ADDENDUM NO. 4

**Chattanooga Public Library
HVAC and Electrical Renovations, Phase Two
City Contract No. L-19-001-201
Chattanooga, Tennessee**

Date: 30 Oct 2019

Sheet M301 HVAC Schedules

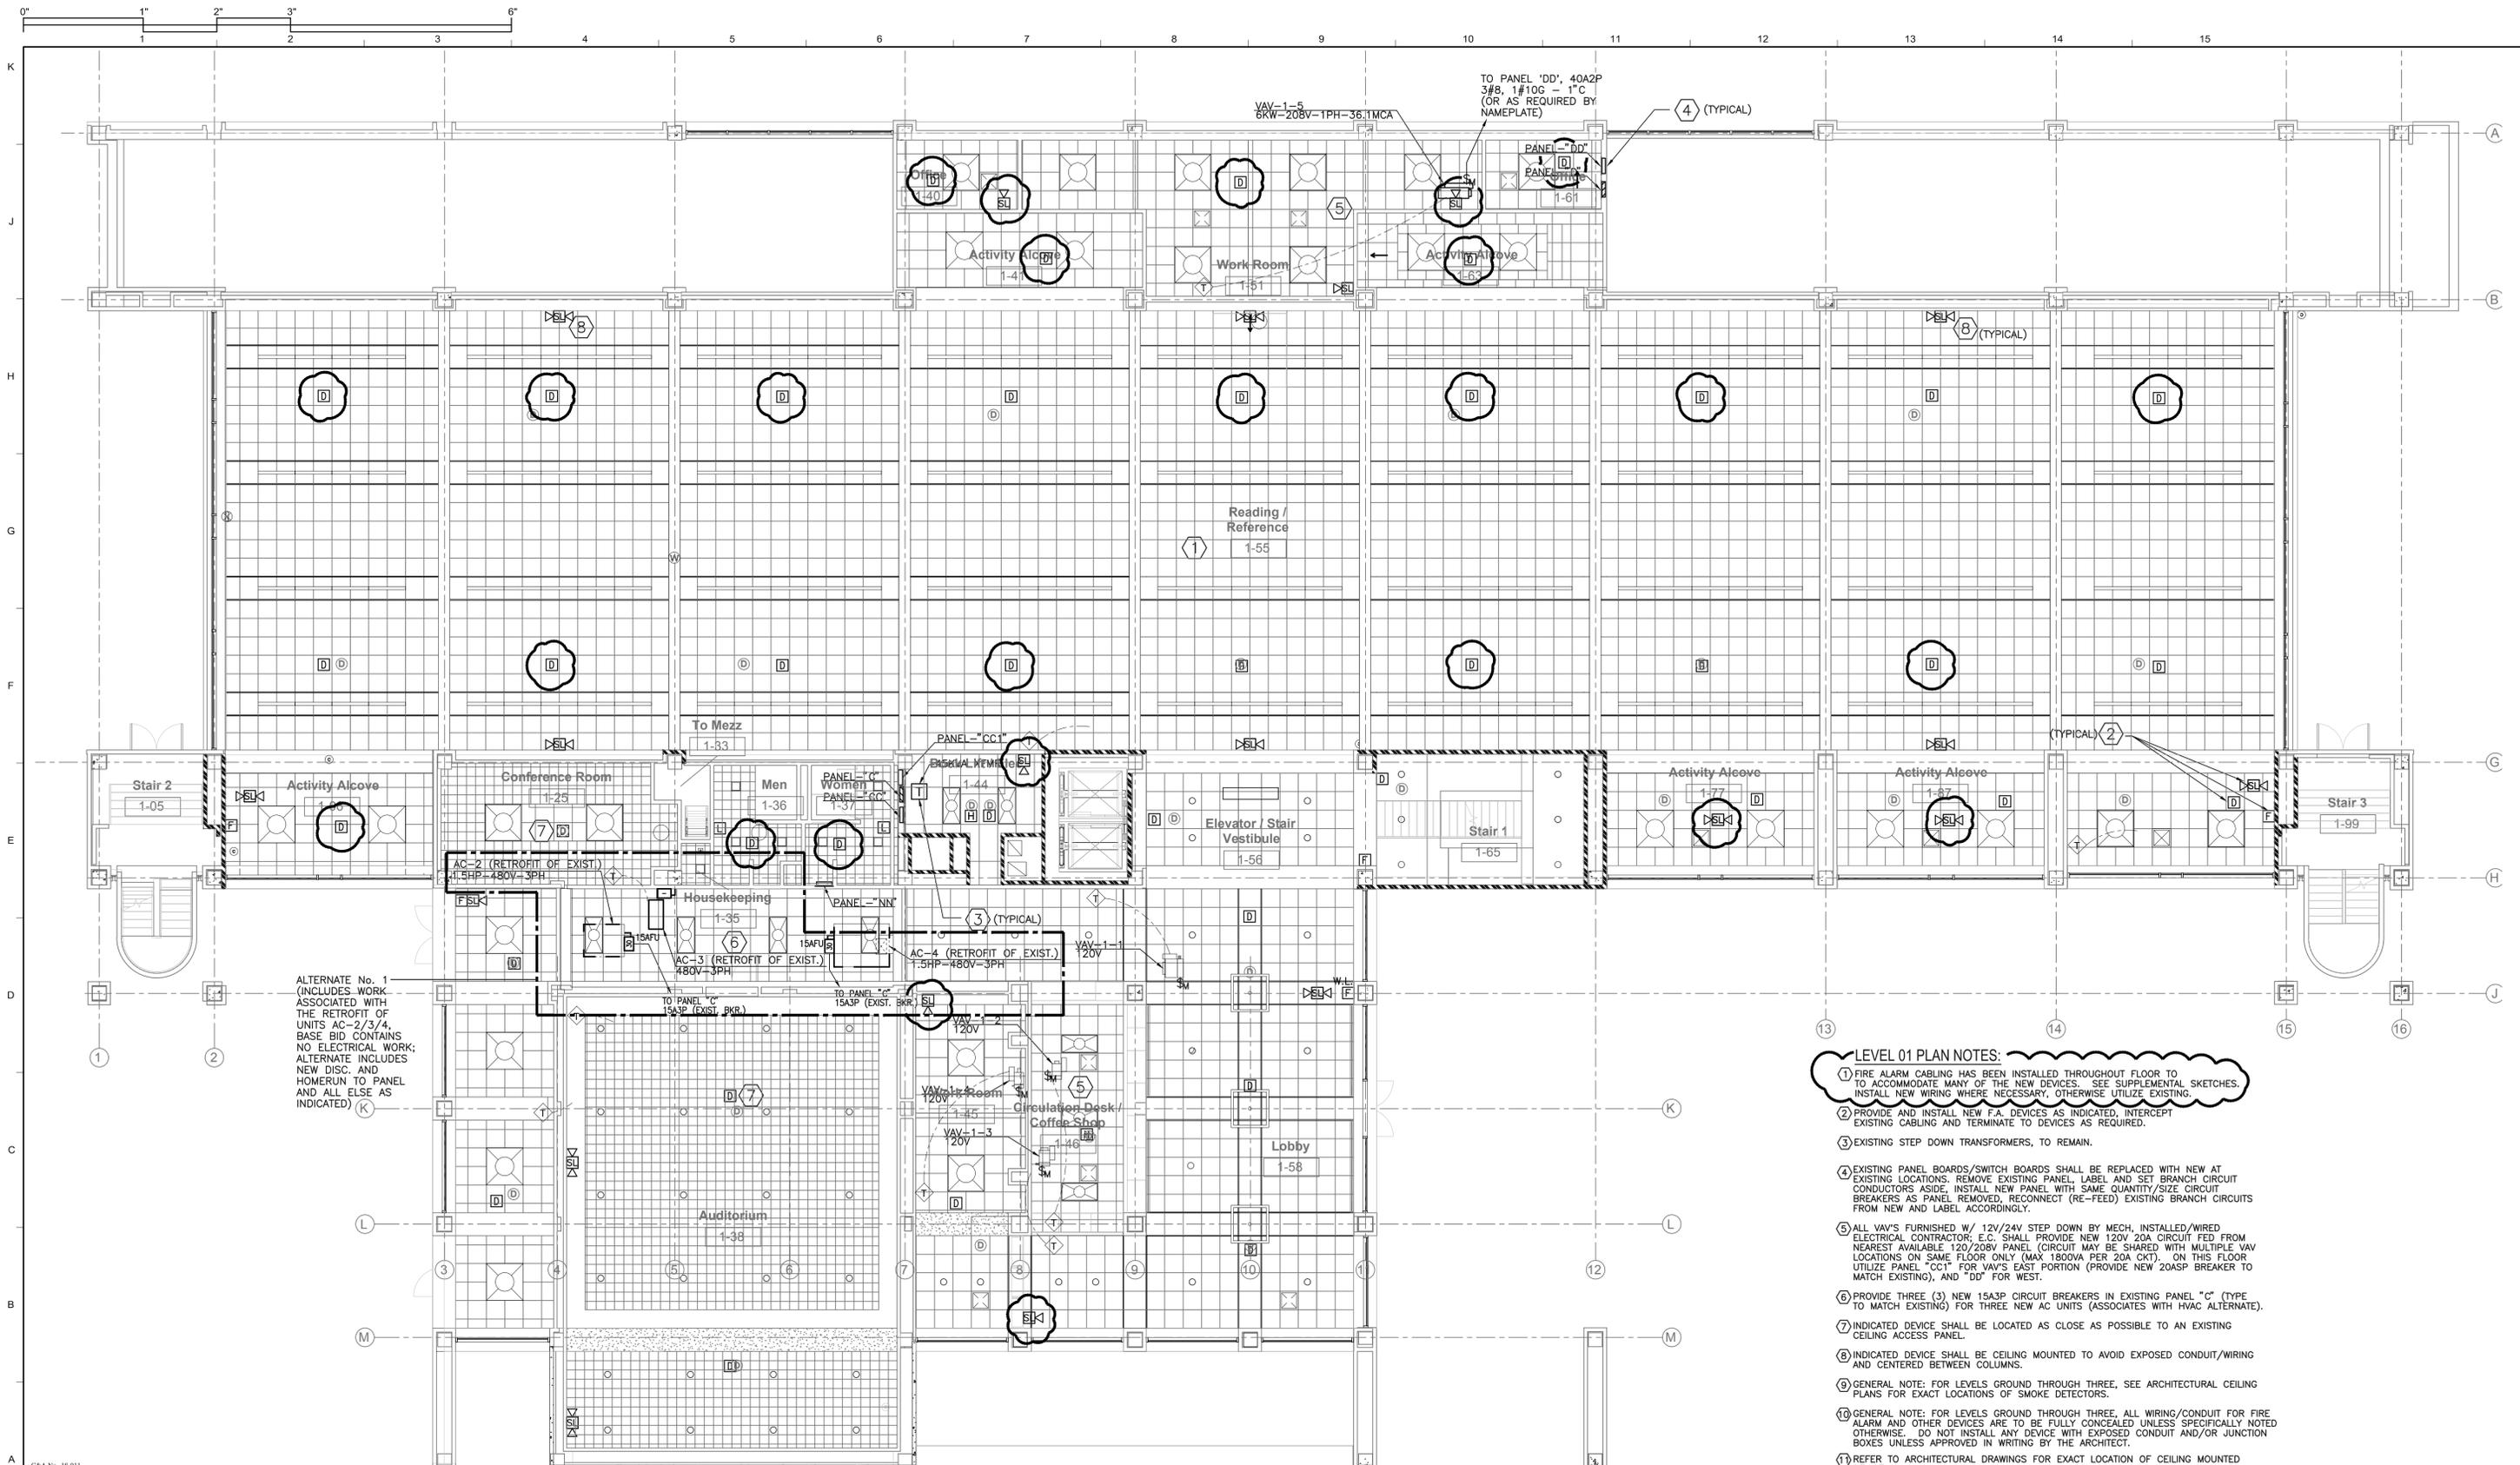
REV 2 NOTE: NO EQUIPMENT CHANGE, SCHEDULE WAS CUT OFF IN PREVIOUS PDF.

Sheet E-101 Electrical First Floor

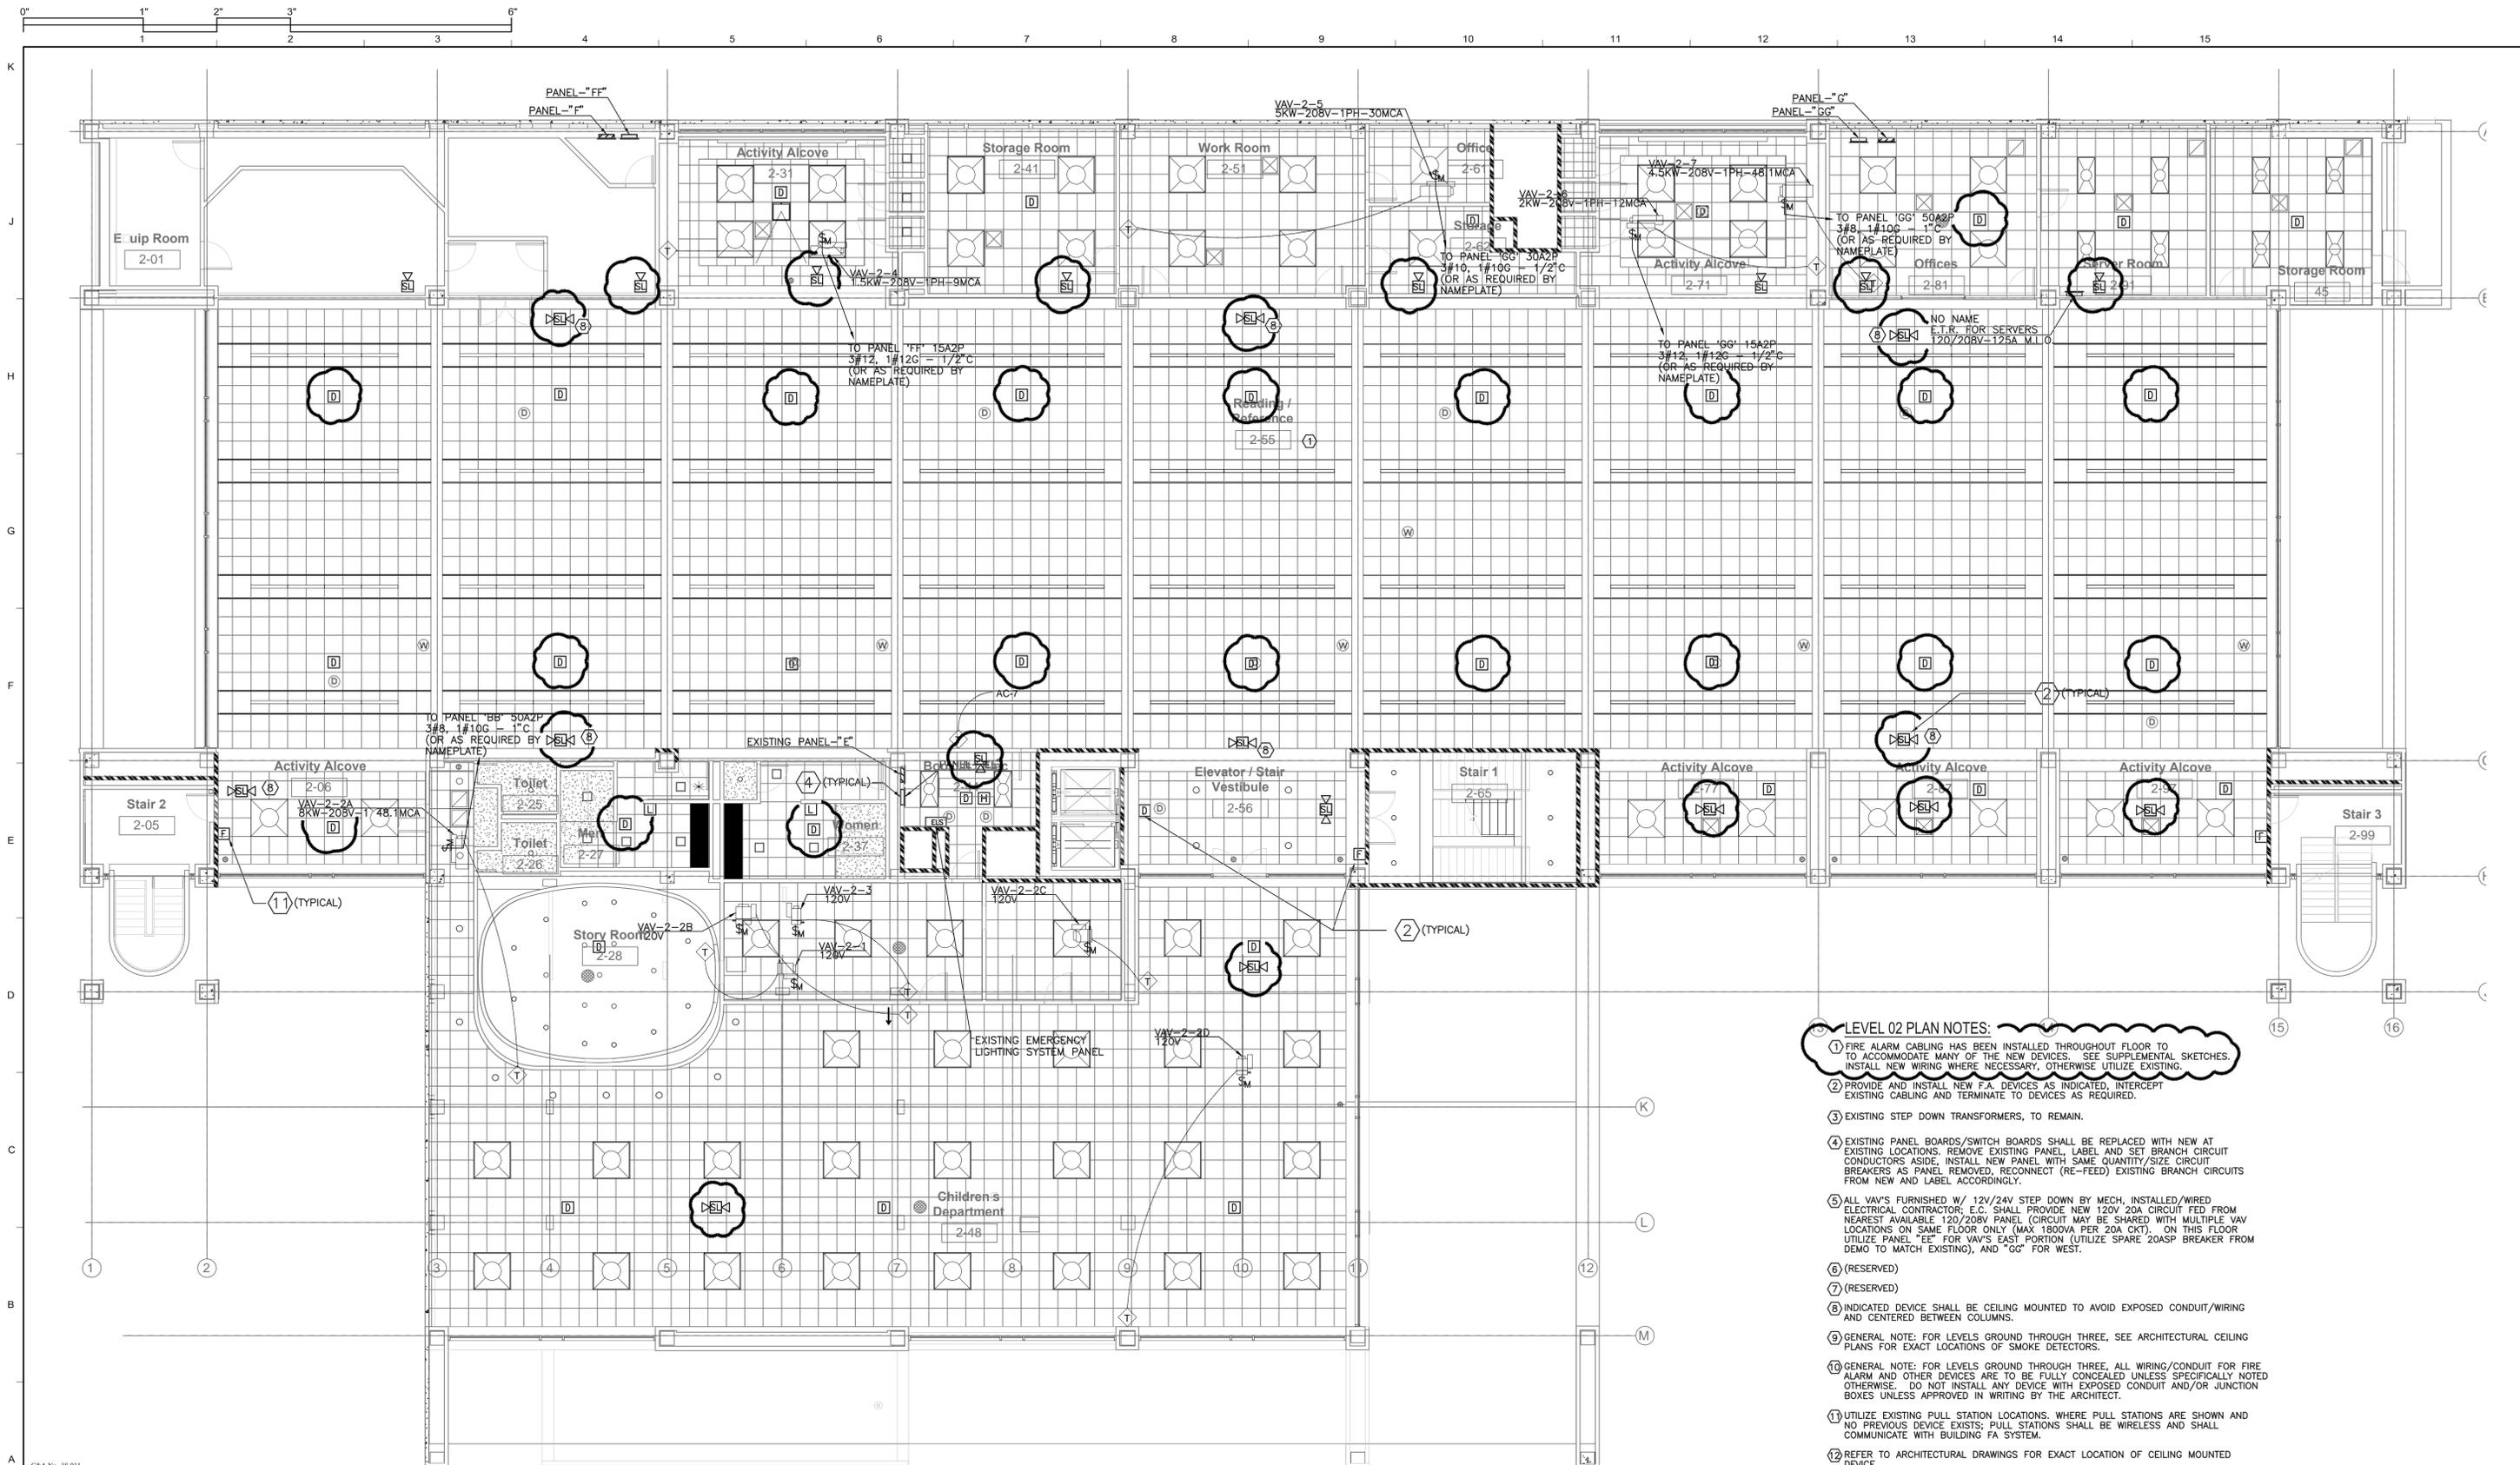
- ALL VAV'S FURNISHED W/ 12V/24V STEP DOWN BY MECH, INSTALLED/WIRED ELECTRICAL CONTRACTOR; E.C. SHALL PROVIDE NEW 120V 20A CIRCUIT FED FROM NEAREST AVAILABLE 120/208V PANEL (CIRCUIT MAY BE SHARED WITH MULTIPLE VAV LOCATIONS ON SAME FLOOR ONLY (MAX 1800VA PER 20A CKT). ON THIS FLOOR UTILIZE PANEL "CCI" FOR VAV'S EAST PORTION (PROVIDE NEW 20ASP BREAKER TO MATCH EXISTING), AND "DD" FOR WEST.

- PROVIDE THREE (3) NEW 15A3P CIRCUIT BREAKERS IN EXISTING PANEL "C" (TYPE TO MATCH EXISTING) FOR THREE NEW AC UNITS (ASSOCIATES WITH HVAC ALTERNATE).

Sheet E-102 Electrical Second Floor

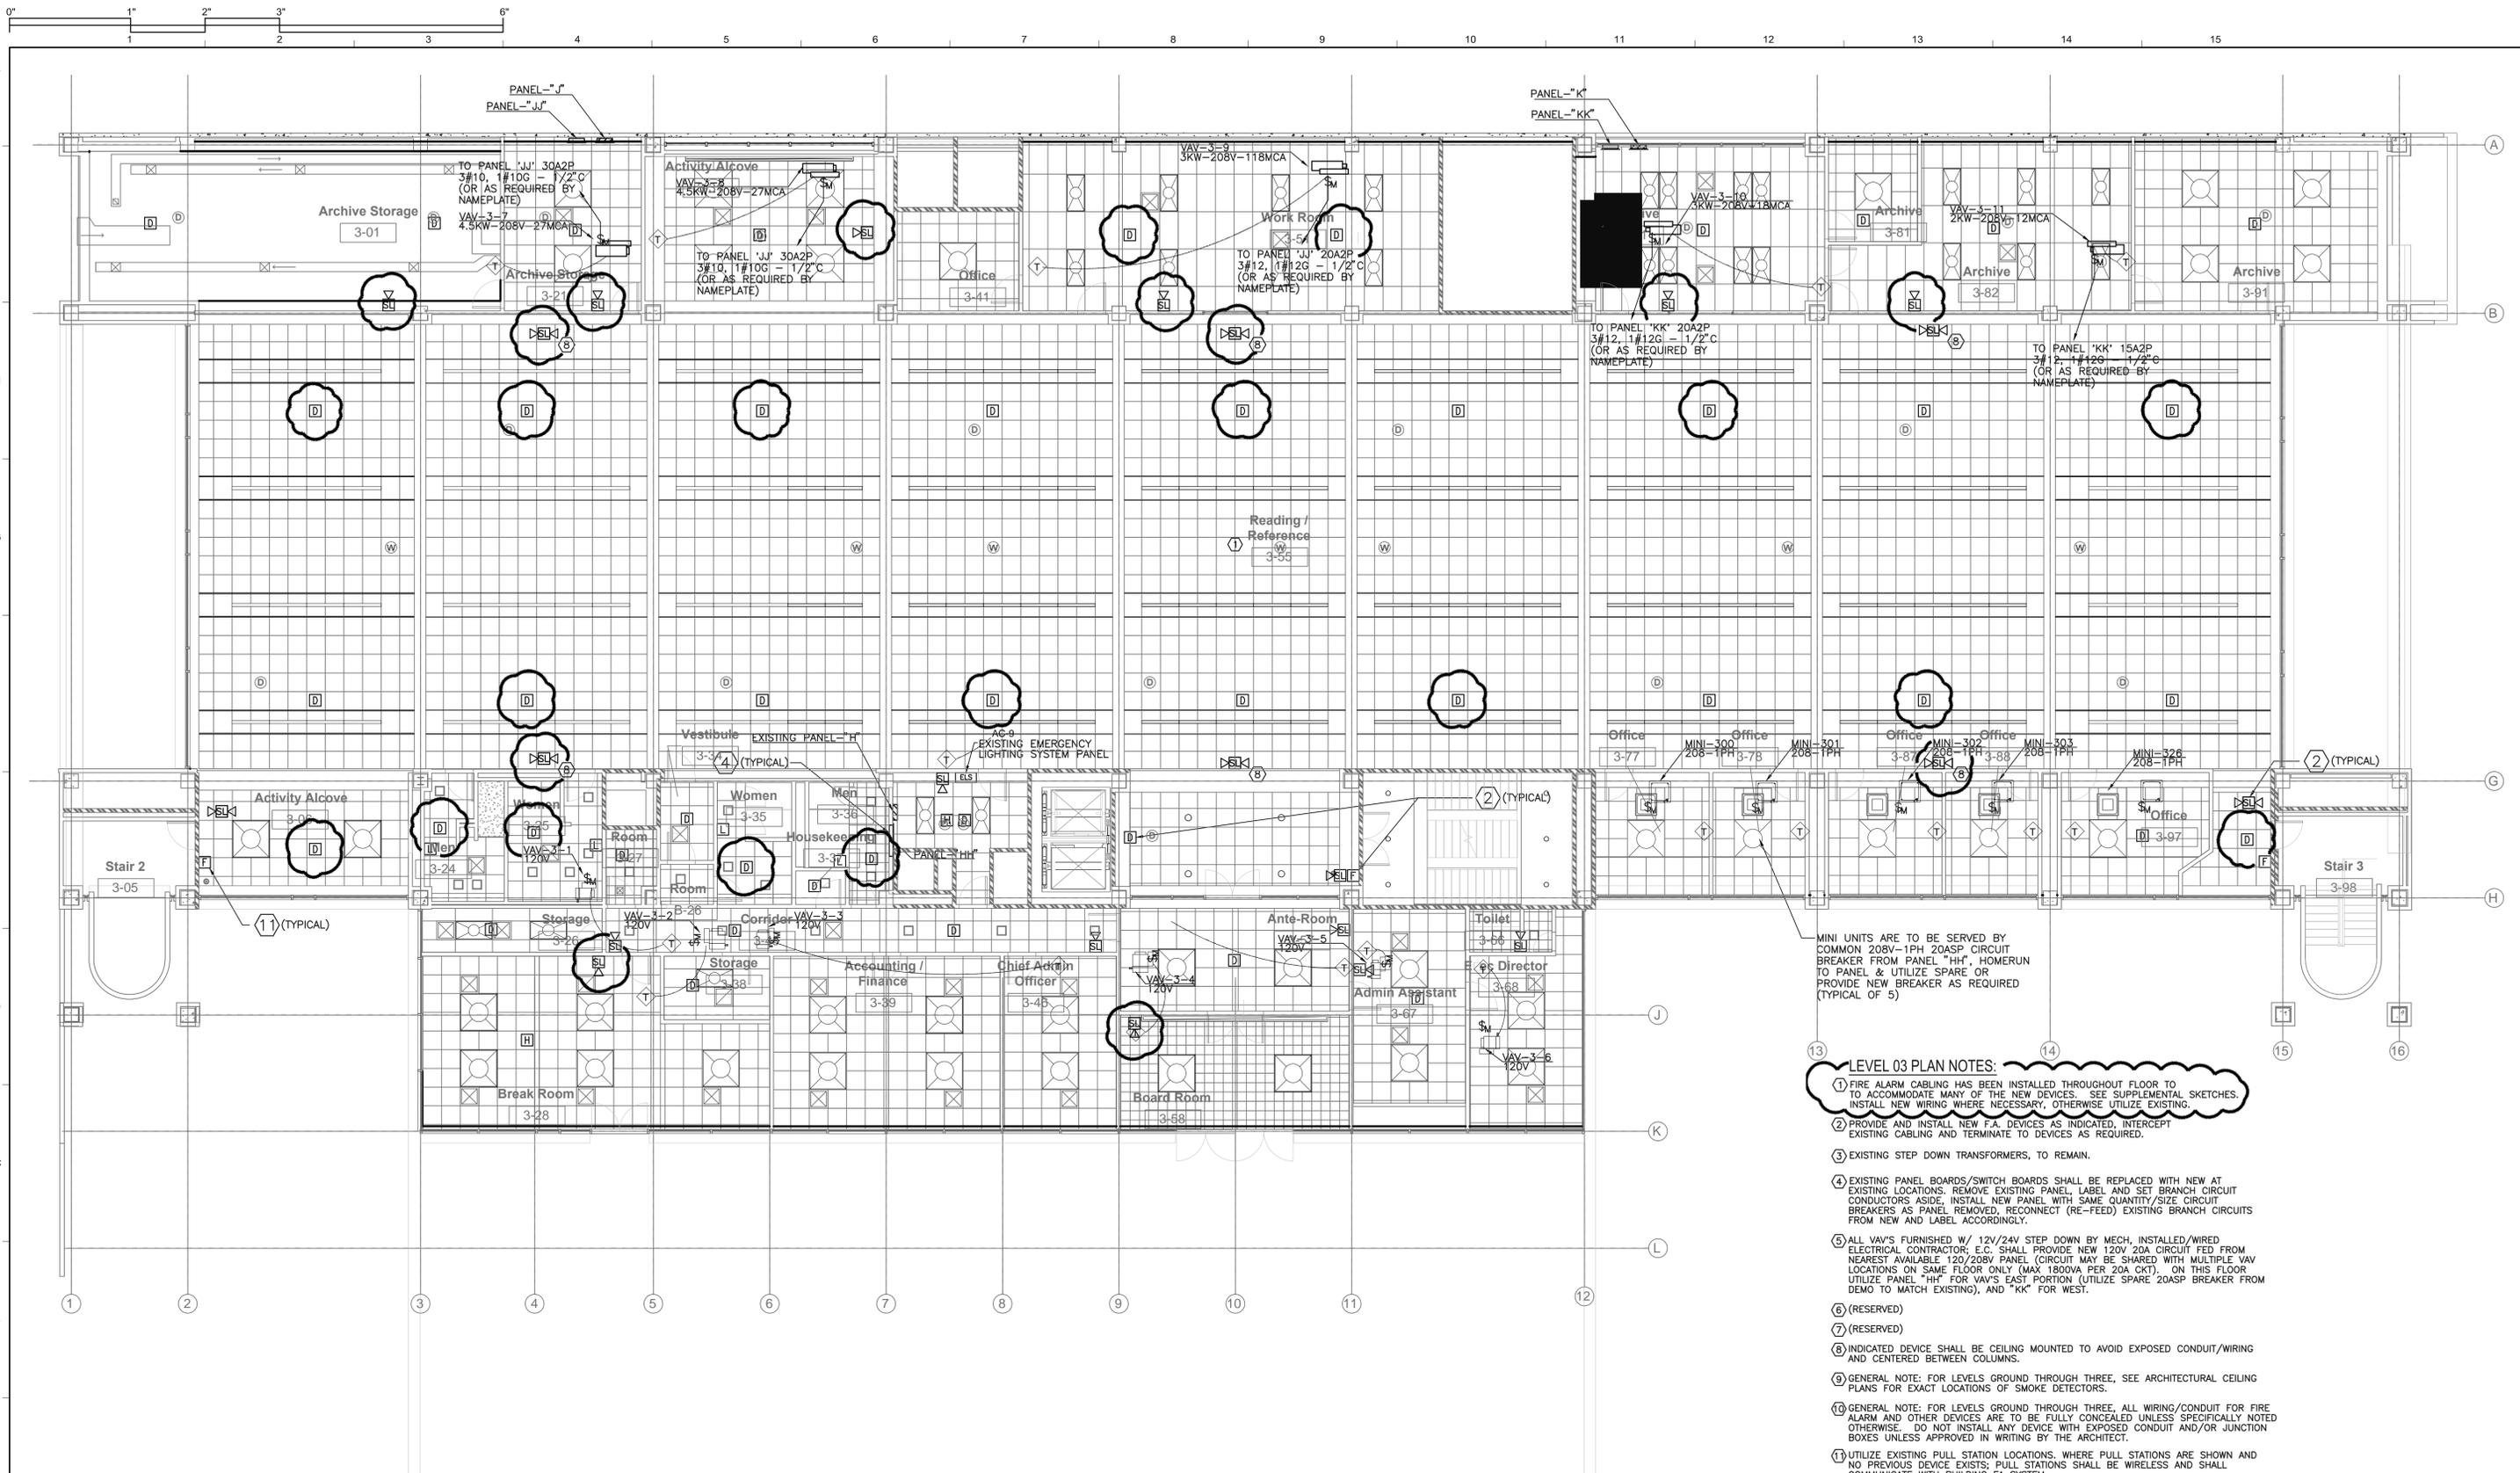
- ⑤ ALL VAV'S FURNISHED W/ 12V/24V STEP DOWN BY MECH, INSTALLED/WIRED ELECTRICAL CONTRACTOR, E.C. SHALL PROVIDE NEW 120V 20A CIRCUIT FED FROM NEAREST AVAILABLE 120/208V PANEL (CIRCUIT MAY BE SHARED WITH MULTIPLE VAV LOCATIONS ON SAME FLOOR ONLY (MAX 1800VA PER 20A CKT), ON THIS FLOOR UTILIZE PANEL "EE" FOR VAV'S EAST PORTION (UTILIZE SPARE 20ASP BREAKER FROM DEMO TO MATCH EXISTING), AND "GG" FOR WEST.
